Job:
RESIDENTIAL FLAT
BUILDING: - 1147, 1149
PACIFIC HWY & 2 BOBBIN
HEAD ROAD PYMBLE

BASEMENT LEVEL 1

SK04A

CROSS VENTILATION DIAGRAM - SECOND FLOOR PLAN
SCALE 1:200 @ A0

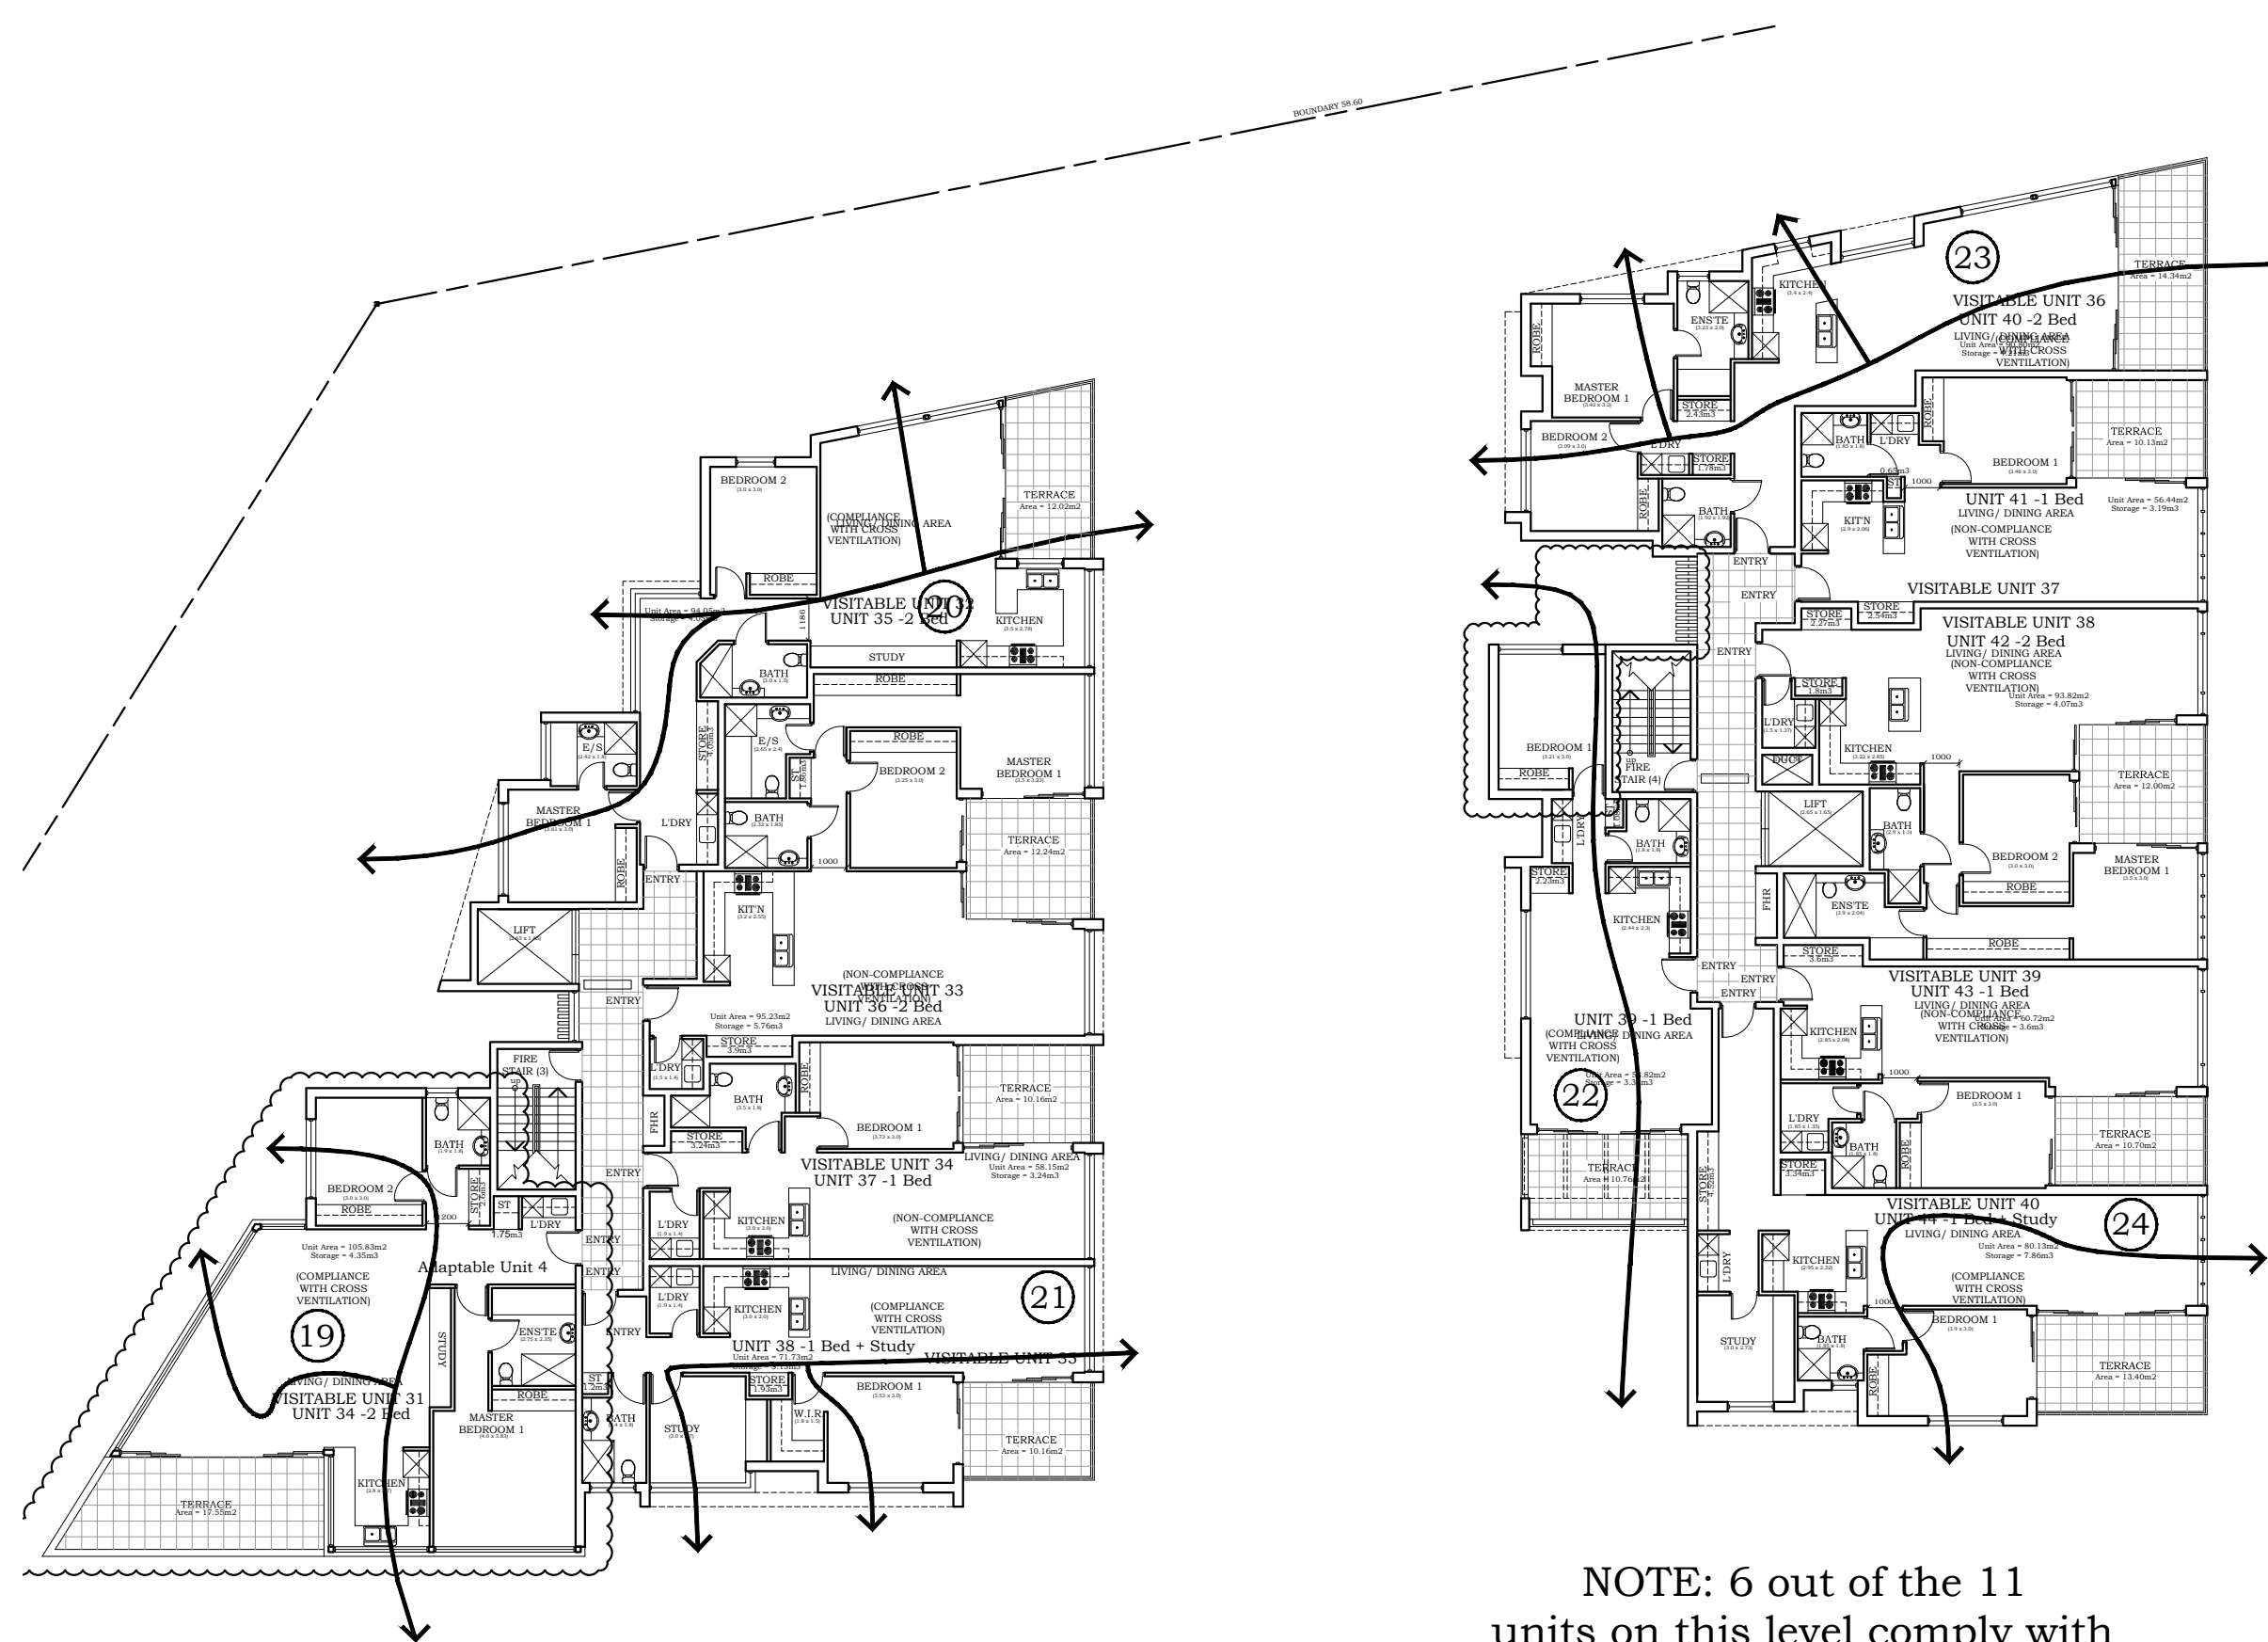
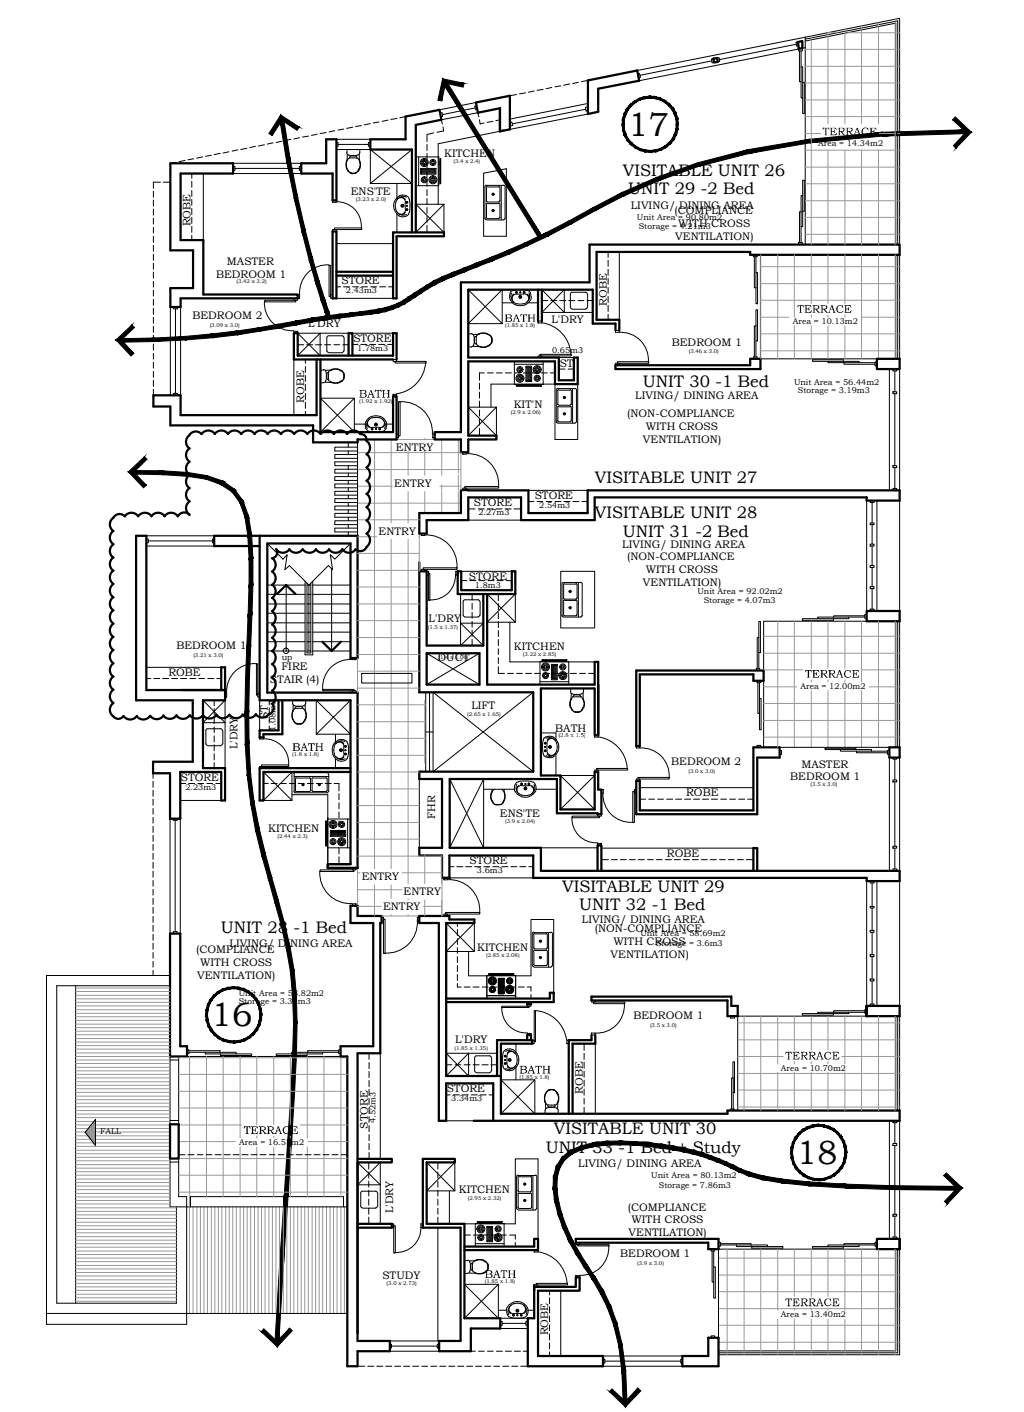
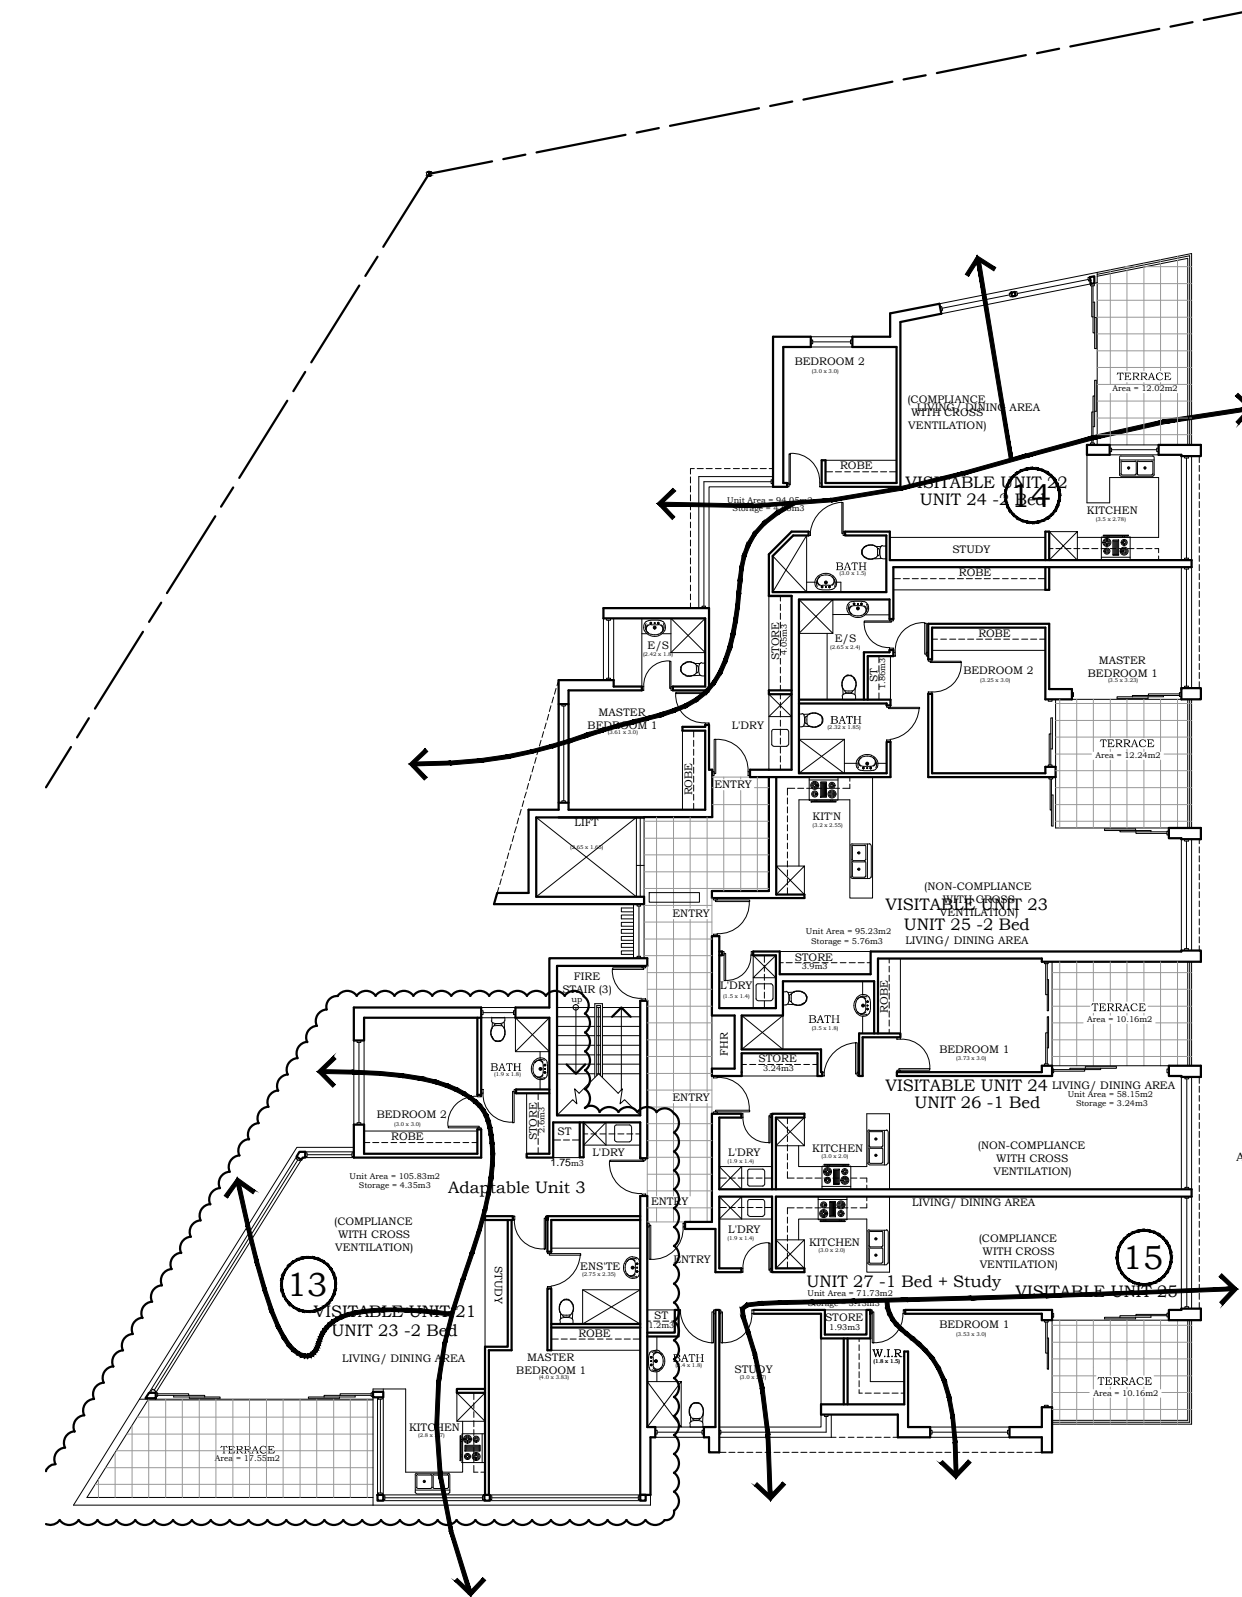
REV	AMENDMENTS	DATE
A	<ul style="list-style-type: none">- the private courtyards adjacent to the northern boundary have been setback further from the northern boundary.- egress path has been added adjacent to fire stair 3- egress path has been amended adjacent to fire stair 2 & 4 so that more doors & windows are 6m away from the egress path- pedestrian path/ramp adjacent to disabled entry now complies with the Australian standards- substation has been moved so that it now lines up with the street frontage.- Courtyard of unit 11 has increased in size.- Paving has been added to the courtyards of unit 7 & 11.- Stepping stones have been removed from the private courtyard of unit 1	30.05.11
